MODIFICATION #4  
WEST LILAC ROAD  
(FROM THE WESTERLY ROUNDABOUT TO THE NORTHERLY BOUNDARY)

**Request for a  
Modification to a Road Standard  
and/or to Project Conditions**

Project Number: TM 5571/5572 Date of Request: April 4, 2013

See Attachment 1 for road design with modification

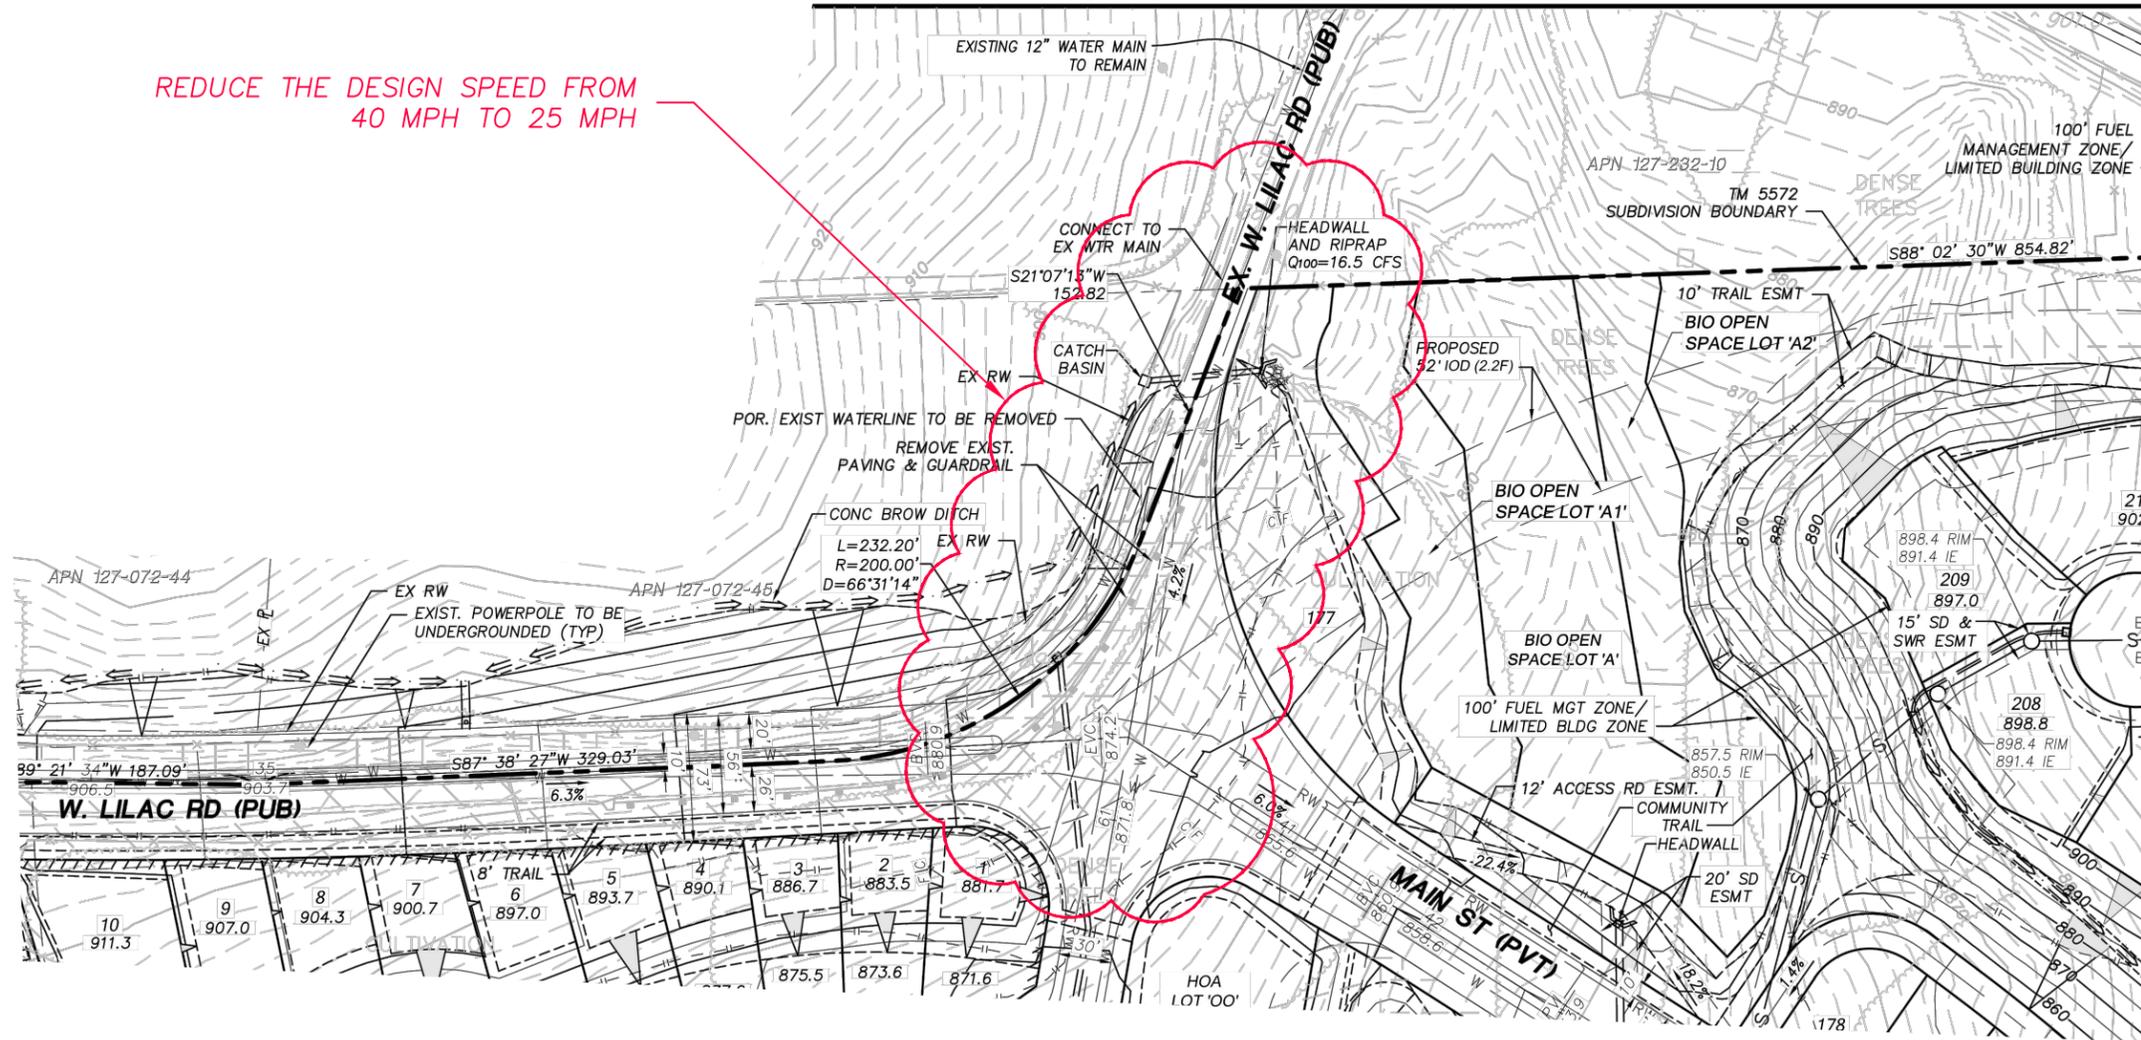
The standard road section for Light Collector 2.2F requires 28' road surfacing width,  
52' ROW, 2' shoulder, and 12' parkway, and a minimum design speed of 40 mph. The requested  
modification is to reduce the design speed to 25 mph and to reduce the road surfacing  
width to 24' with 28' graded width.

# ATTACHMENT #1

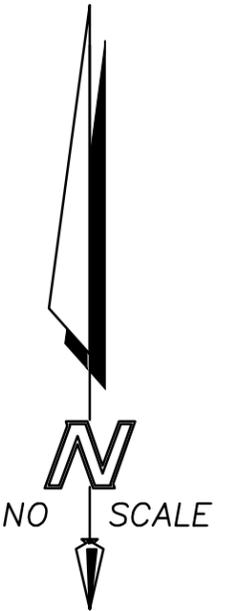
REDUCE THE DESIGN SPEED FROM  
40 MPH TO 25 MPH

This 300' long portion of road is a transition from the onsite roundabout to the existing West Lilac Road.  
Without the transition, the actual length of full 2.2F width road that could be constructed is only 70' long,  
due to the transition from the roundabout and to existing West Lilac Road. Likewise, Increasing the design  
speed on this short piece of existing road to 40 mph will require making the proposed road alignment longer to  
accommodate the necessary vertical curve, thus increasing offsite grading and biological impacts and requiring  
offsite ROW acquisition. The projected ADT for this segment of roadway is very low, which the slower design  
speed could easily accommodate. Additionally, it is desirable to reduce the speed of traffic in a roundabout  
approach to increase safety and roundabout performance. This request also maintains consistency with existing  
road characteristics and geometrics
